Technical Service Bulletin

Topic	Reverse camera image - Blurred
Market area	Bentley: worldwide (2WBE),Hongkong-Macau (5HK)
Brand	Bentley
Transaction No.	2054229/3
Level	EH
Status	Released for publishing
Release date	Aug 21, 2019

New Continental GT and New Continental GTC

Figure 1

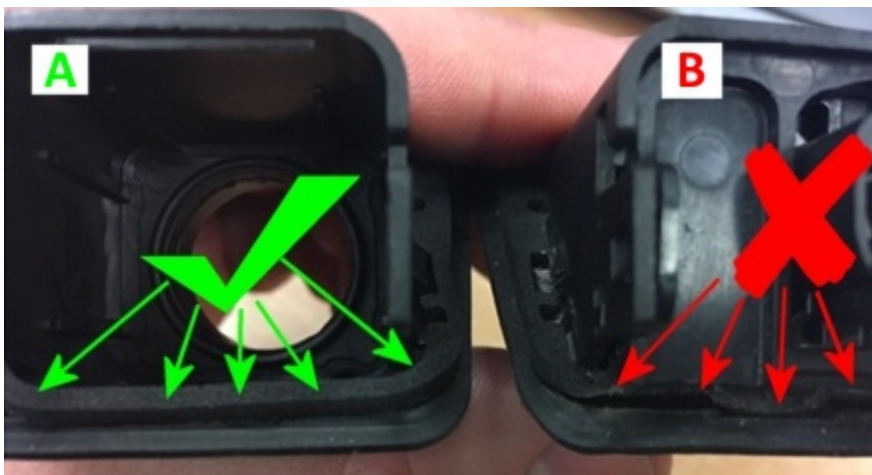
3) Referring to Figure 1 - Carry out an inspection of the reverse camera holder foam seal

- Should the seal be as shown (Point A) this is to correct specification, should the seal be at the correct specification and the reverse camera has evidence of moisture on OR within the lens - Allow the camera to fully dry out ensuring that no moisture is evident then carry out the modification instructions as detailed in step 5 - **Reverse camera holder modification instructions**
- Once the modification has been completed - Refit the reverse camera holder/reverse camera ensuring the seal is fitted/located correctly - Refer to Repair manual Rep.Gr 94 **IMPORTANT:** Ensure the instructions within the Repair manual are strictly adhered to including all camera calibration instructions

4) Should the seal be as shown in Figure 1 (Point B) this is not to correct specification, a new replacement holder should be sourced/ordered

Figure 2

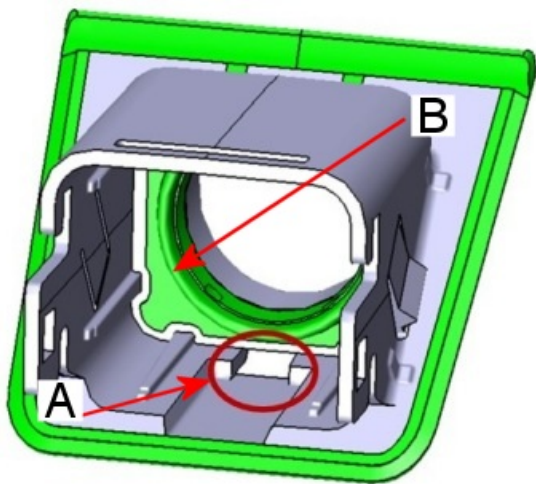
IMPORTANT: REFERRING TO FIGURE 2 - PRIOR TO ADDING THE HOLE (Point A) THE OPERATIVE SHOULD FAMILIARIZE THEMSELVES WITH THE LOCATION OF THE SEAL (Point B)

The seal should remain intact to ensure the seal does not split or dislodge away from the housing as the fitting position of the camera may be compromised should the seal be damaged
